# Technical Service Bulletin

## 30 Haldex coupling does not work (DTC C111204)

30 16 20 2043144/1 February 1, 2016.

Model(s)	Year	VIN Range	Vehicle-Specific Equipment
A3, Q3	2015 - 2016	All	quattro

**Figure 1.** Drain plug for Haldex oil (A), oil filler plug for Haldex oil (B), gear oil drain plug (C), oil filler plug for gear oil (D).

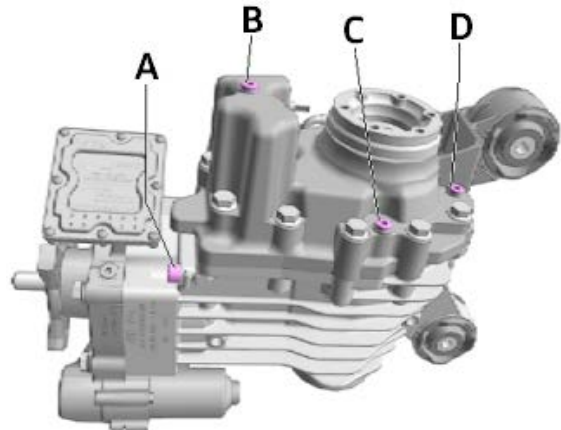
The final drive and the Haldex coupling have separate oil circuits. Refer to ETKA for information on which oil to use, and refer to the Elsa Repair Manual for draining and filling information.

- The Haldex coupling uses high performance oil for Haldex couplings, and the final drive uses gear oil.
- The image at right (Figure 1) shows the correct drain and fill plugs.
